Preliminary Stormwater Control Plan

DANVILLE HOTEL SITE

Updated: February 28, 2011

SUBJECT: Responses to Comments for the Preliminary Stormwater Control Plan
Danville Hotel
Danville, California

Appendix C
Conceptual Flow Through Planter Details

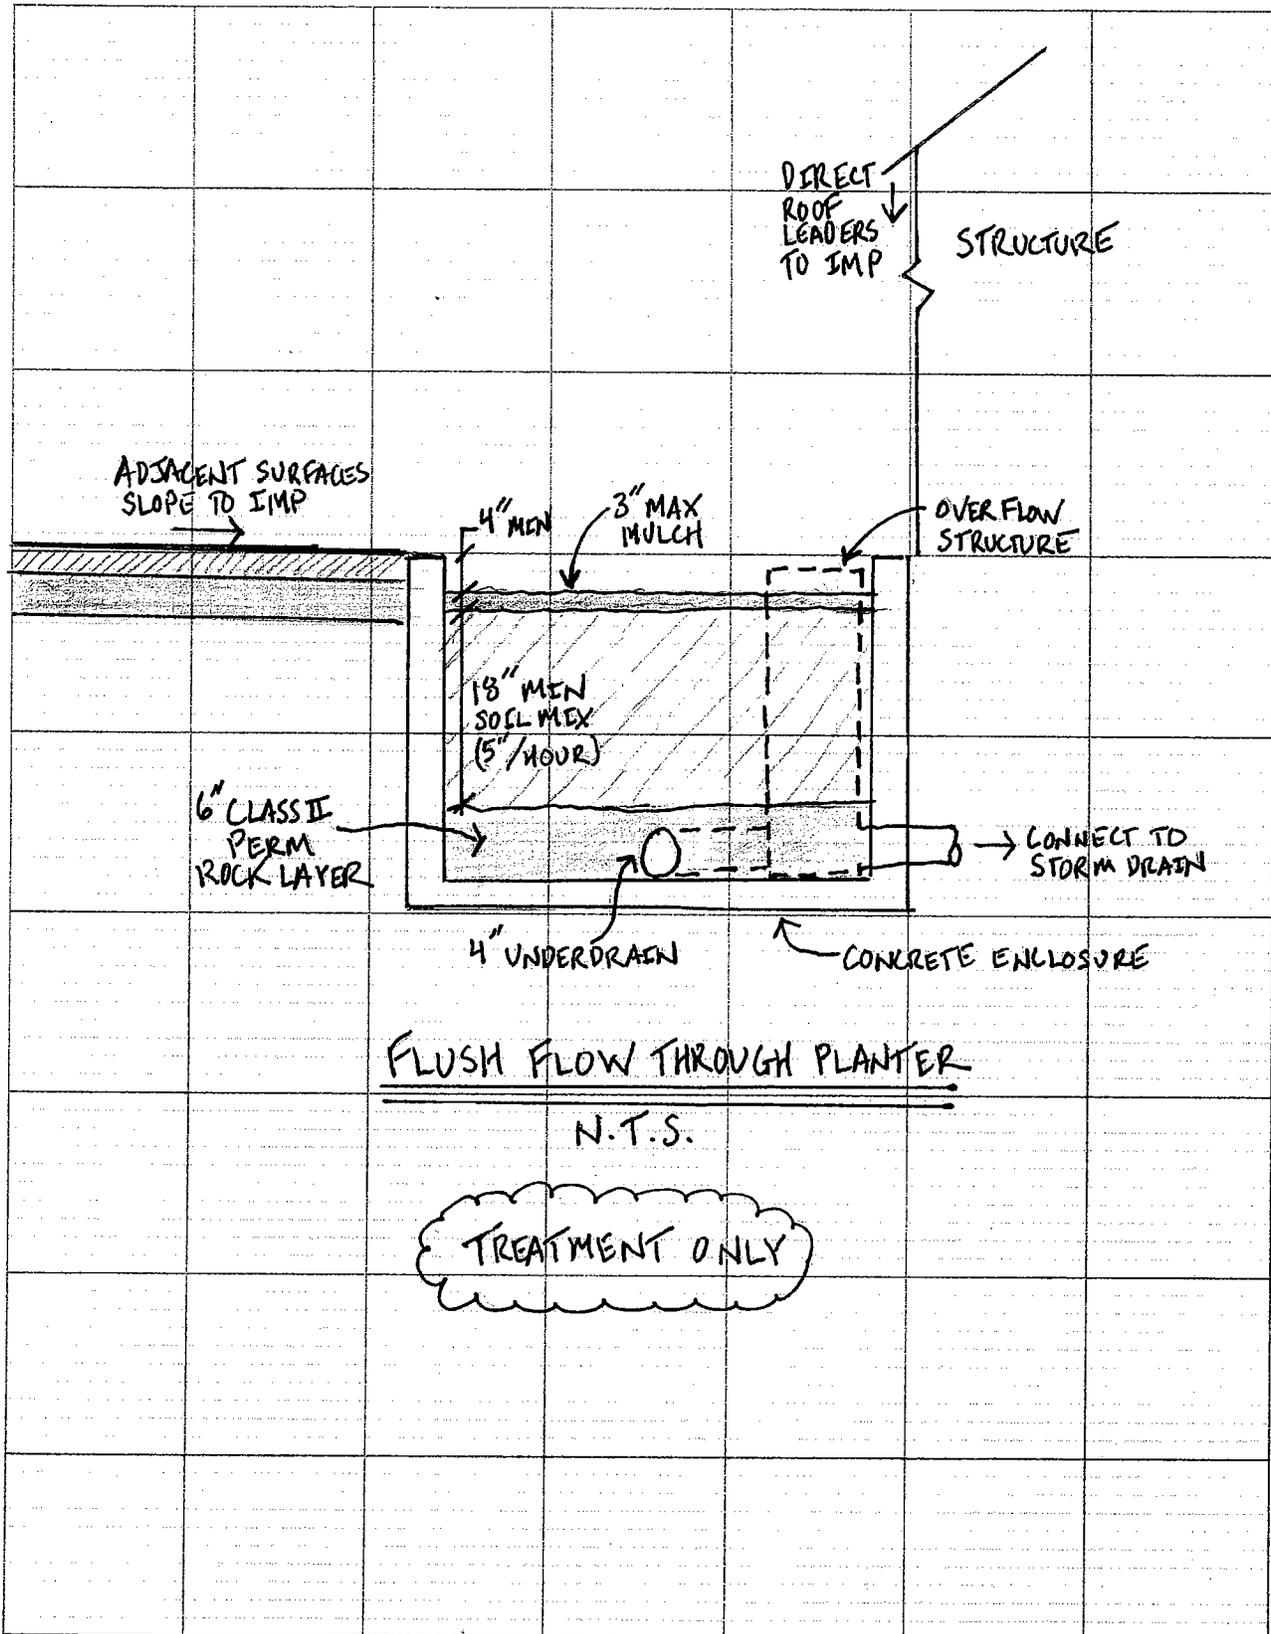
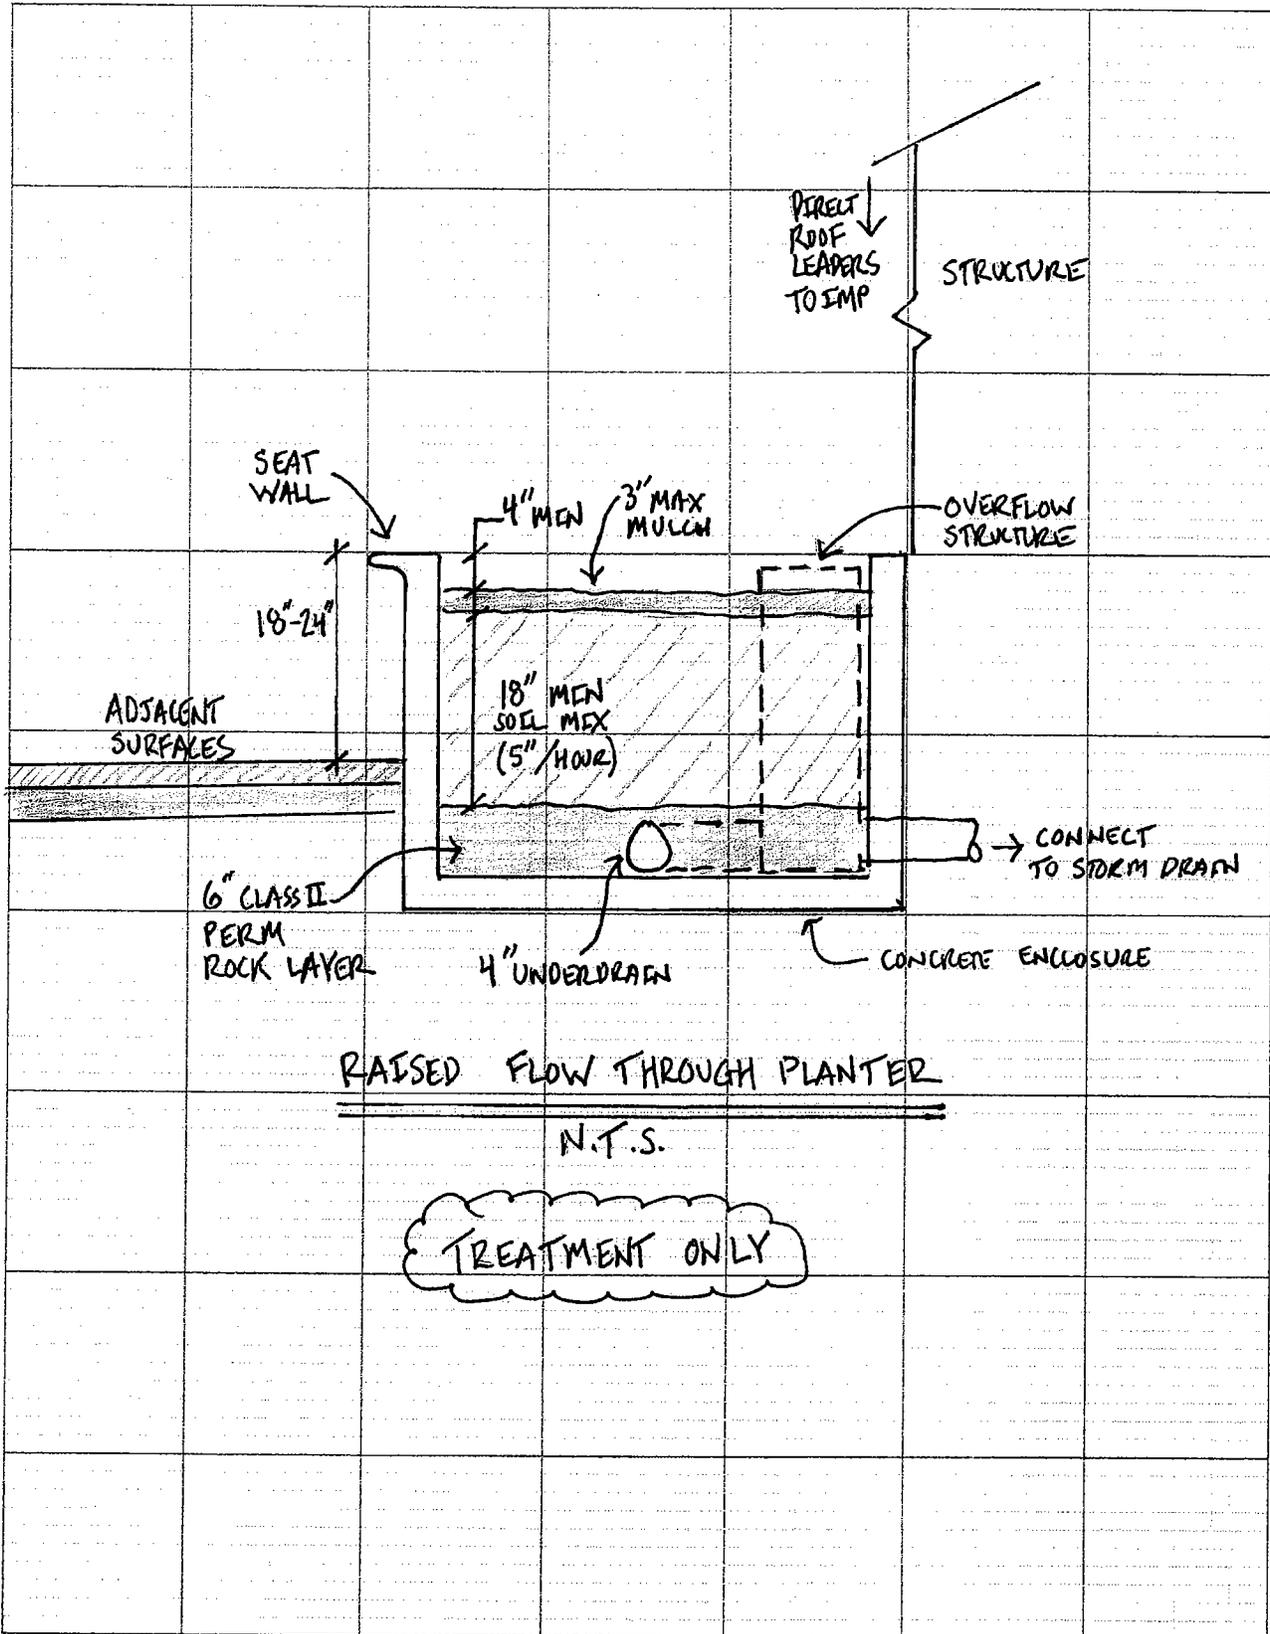
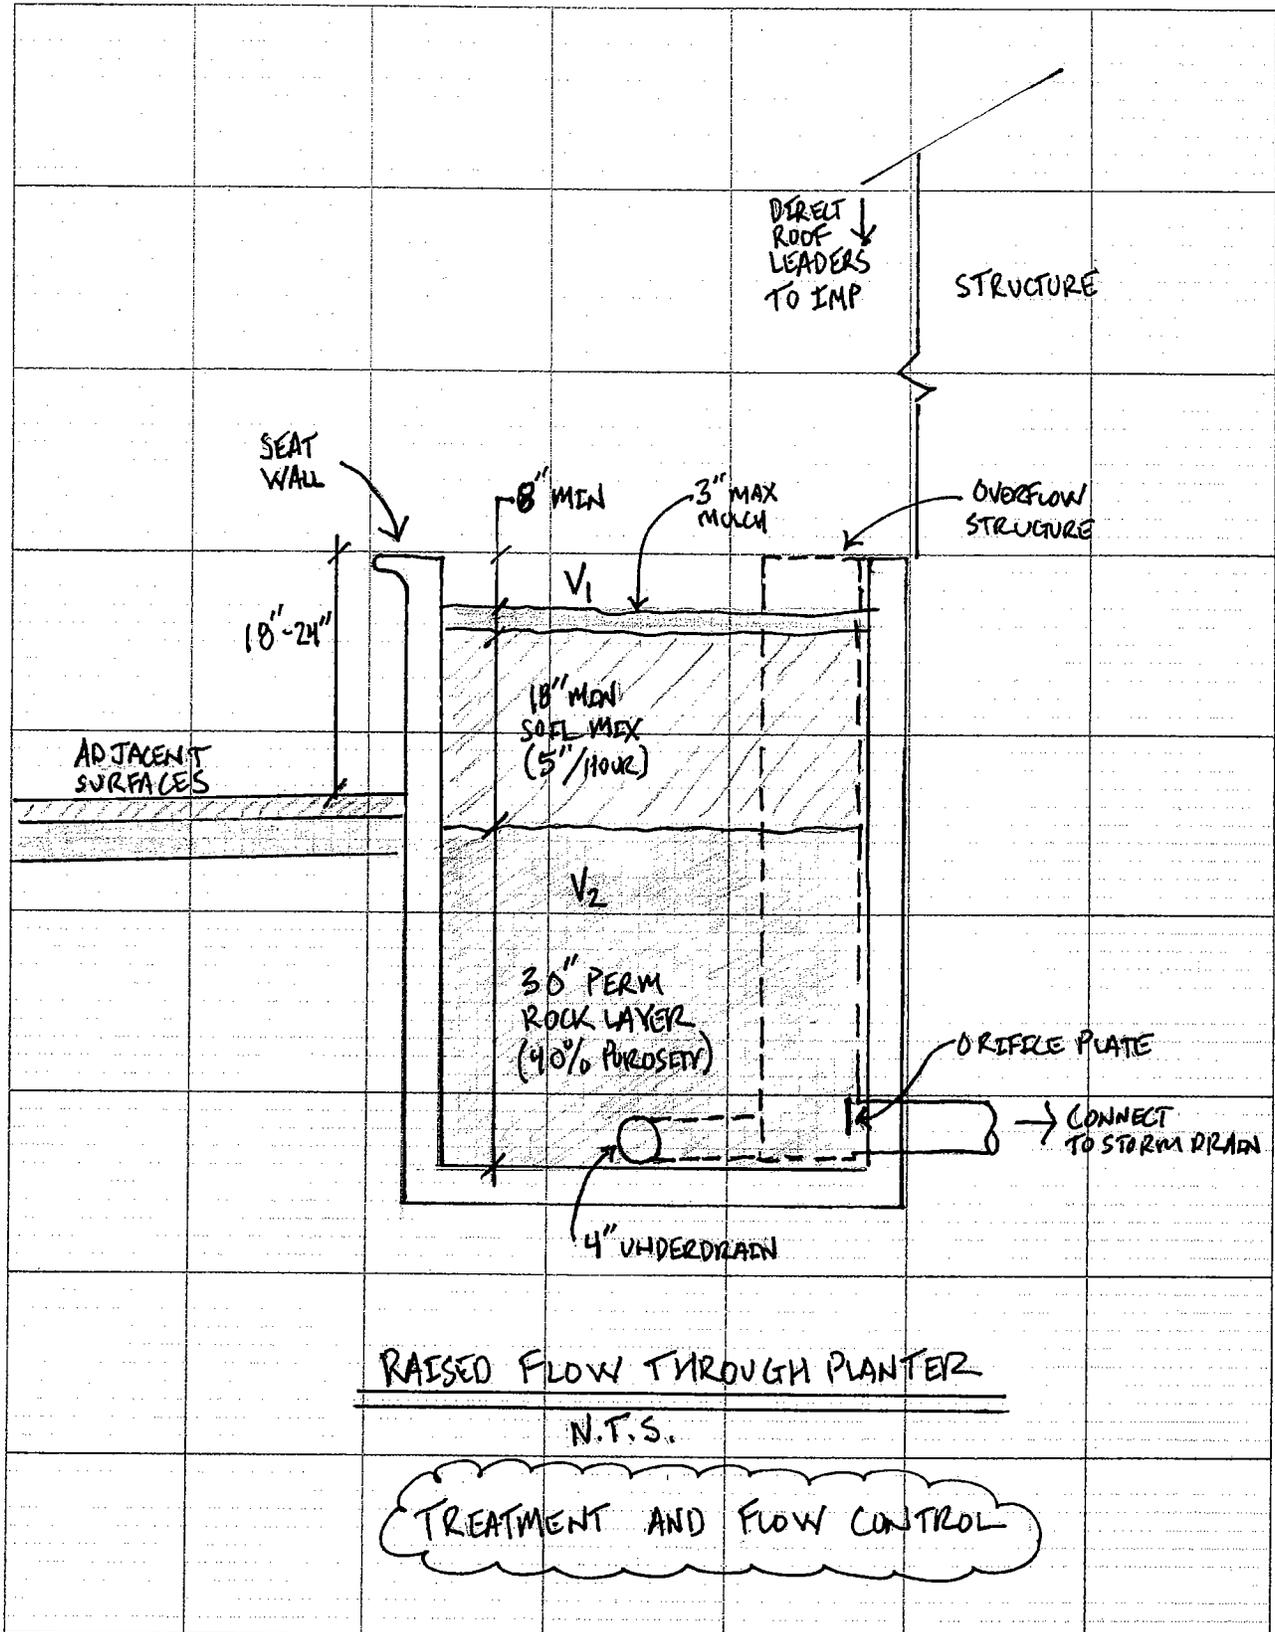
Comment 5. The ponding depth detailed in the IMP drawings is not consistent with the C.3. Guidebook recommendations. The ponding depth needs to be deepened to match the Guidebook. The detail needs to be corrected and a note needs to be added to specify that the soil mix to be used will align with the recommended mix called out in the most current version of the C.3 Guidebook at the time of construction.

Comment 8. The detail provided for the flush planter indicates a 4” ponding depth where the standard specifications for these types of facilities call for a 6” ponding depth – being 2 inch” freeboard and 4” ponding depth. Detail should be modified to match the standard specifications. [Note: Preliminary Landscape Plans for project provide a more detailed planter detail. CBG should contact Samantha Haimovitch with Gates + Associates so landscape planter “details” can be coordinated.]

Response: Please see enclosed Pages 79 & 80 from the C.3 Guidebook. These outline the recommended design parameters for a flow-through planter in a treatment only condition. These parameters indicate that a 4-inch depth to the planter surface is acceptable when adjacent to walkways. We have proposed the treatment only planter surfaces be 4-inches deep because they are typically adjacent to walkways.

Response: Please see the response to comment (5) above. We will coordinate final details of the flow-through planters with Gates and Associates during the final design stage of the project.

EXHIBIT 3
 PROPOSED ON-SITE
 TREATMENT AREAS
 DANVILLE HOTEL

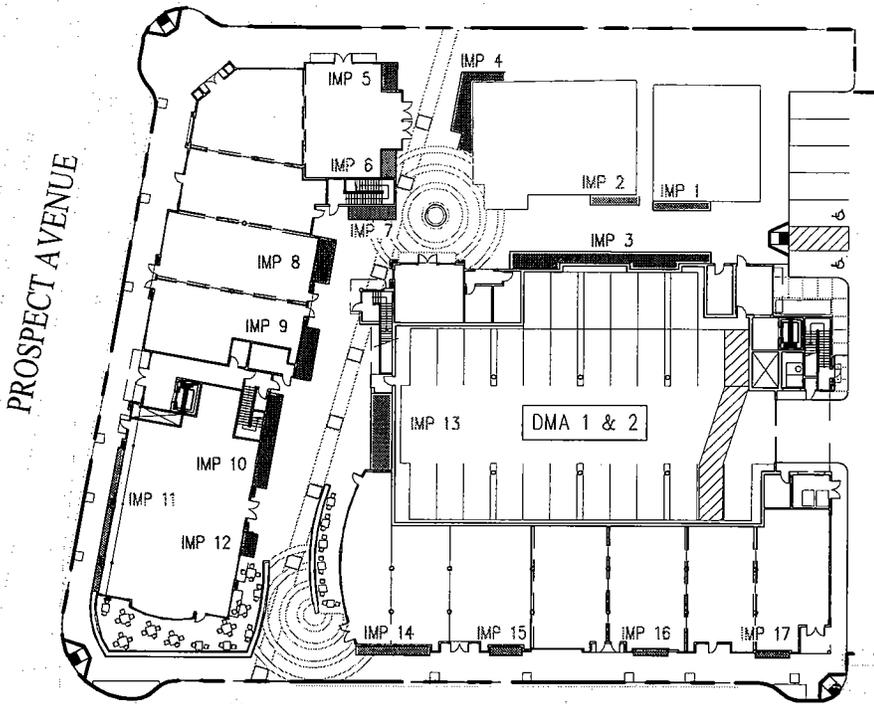
Comment 2. The width of IMP-11 does not seem to be sized to properly function. This may be the case for other planters if they are similar in size.

Response: IMP 11, 16 and 17 are proposed to be flow-through planters providing treatment only and are less than 2 feet wide. The C.3 Guidebook does not indicate a minimum width for this type of facility. We understand that the final design will need to demonstrate that these facilities can function properly. The roof downspouts, plantings and overflow structures will need to be carefully placed to ensure the drainage is adequately dispersed and treated within the planter. These details will be addressed during the final design.
